# DEVELOPMENT REVIEW BOARD REPORT

**69-DR-2000#3**  
**Chase Bank**

16852 N. Thompson Peak Parkway

## **Stipulations for Case: Chase Bank 69-DR-2000#3**

EXTENSION ELEVATIONS

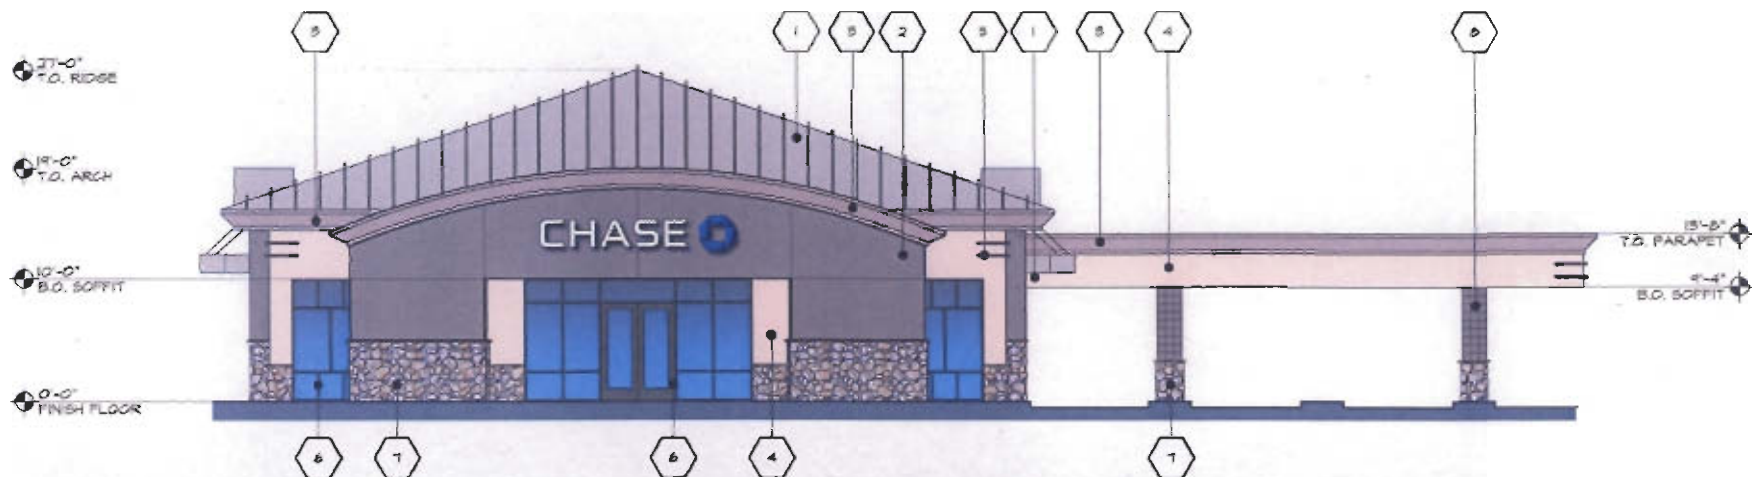
The windows and doors are shown on the elevation plans with 18-inch recess but this element is not shown on the floor plans. Staff has included a stipulation that requires windows and doors with 18-inch recesses.

8. Dooley wall fencing shall not be allowed.
9. All walls shall match the architectural color, materials and finish of the building(s).
10. With the final plans submittal, the floor plans shall be drawn consistent with the elevation plans to provide 18-inch recessed windows and doors.
